Memorandum

Date: April 23, 2015

To: SOUTHERN NEVADA DISTRICT BOARD OF HEALTH

Subject: Variance Request to Permit an Existing Individual Sewage Disposal System (ISDS) on an Undersized Lot Served by an Off-Site Public Water Supply with a Deep Absorption Pit within Twenty (20) Feet of a structure and Ten (10) Feet of the Property Lines (APN 129-36-510-026)

Attachment F: ISDS Density Map

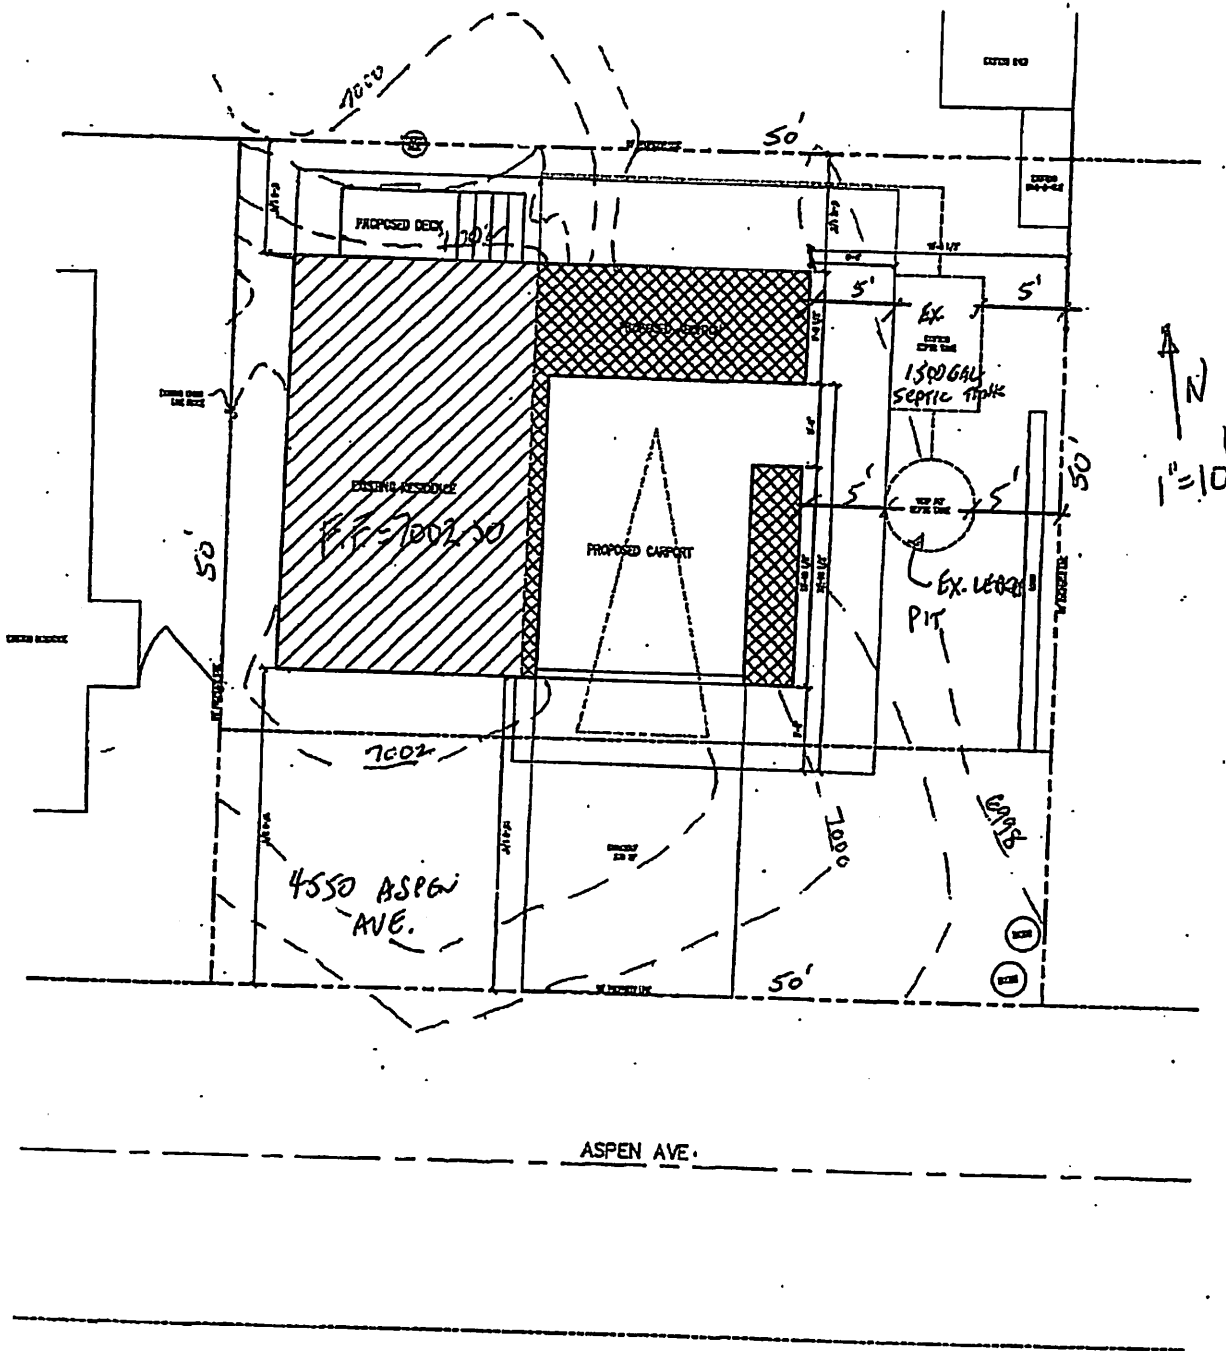
There is one existing well located upgradient and within six hundred (600) feet of the proposed deep absorption system which is in proximity to a high density of existing ISDS's. (See attached ISDS Density Map). The map also shows "185 Lots with a traceable permit for a septic system within a square mile of APN 129-36-510-026." The offsite water quality will not be affected by the proposed septic system. The closest neighboring building to the proposed ISDS is a distance of fifty (50) feet, thirty (30) feet more than the normal twenty (20) foot minimum required separation, but acceptable per attached Cone of Influence Letter dated November 14, 2014 by Steven E. McCullough, P.E. of Black Mountain Geotech Engineering. The closest property line is five (5) feet from the ISDS where ten (10) feet minimum separation is normally required by regulations.

185 Parcels permitted for a septic system within 1 circular square mile of the parcel.
1 well within 600' of the parcel 129-36-510-026
